# Access Compliance Report

## Public Rights-of-Way

### (Curb Ramps)

Intersection ID: N/A	Main Street: WALNUT_LOOP_RD	Cross Street: WOODBINE_WALK_RD	Location: SE
ADA ID: 8BDD1CD381BD	Ramp Type: Perp	Initial Pass/Fail: Fail	Overall Compliance: No
		Severity Score: 12.5

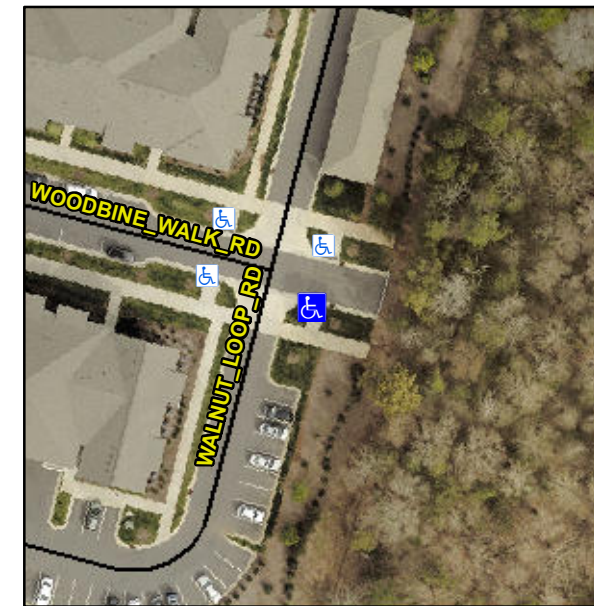
**R304.5.3**

Compliance	Description	Data	Compliance	Description	Data
N/A	Ramp Length (in)	79.0	Yes	Ramp Slope (%)	7.1
Yes	Ramp Width (in)	94.0	No	Ramp XSlope (%)	5.3
N/A	Flare Type LT	N/A	N/A	Flare Type RT	N/A
N/A	Flare Slope LT (%)	N/A	N/A	Flare Slope RT (%)	N/A
N/A	Flare Traversable LT?	N/A	N/A	Flare Traversable RT?	N/A
N/A	Landing Length (in)	N/A	N/A	DWS Provided?	N/A
N/A	Landing Width (in)	N/A	N/A	DWS Contrast?	N/A
N/A	Landing Slope (%)	N/A	N/A	DWS Length (in)	N/A
N/A	Landing X Slope (%)	N/A	N/A	DWS Full Width?	N/A
N/A	Landing Curb? (Y/N)	N/A	N/A	DWS Offset (in)	N/A
N/A	Shared Landing?	N/A			
N/A	Gutter Ponding?	N/A	N/A	Gutter Slope (%)	N/A
N/A	Gutter Lip Ht (in)	N/A	N/A	Gutter X Slope (%)	N/A
N/A	Painted X Walk1?	No	N/A	Painted X Walk2?	N/A
	X Walk 1 Direction	To NE		X Walk 2 Direction	N/A
N/A	X Walk 1 Width (in)	N/A	N/A	X Walk 2 Width (in)	N/A
	X Walk 1 Slope (%)	0.8		X Walk 2 Slope (%)	N/A
	X Walk 1 X Slope (%)	4.9		X Walk 2 X Slope (%)	N/A

**Remove & Replace Entire Ramp.**
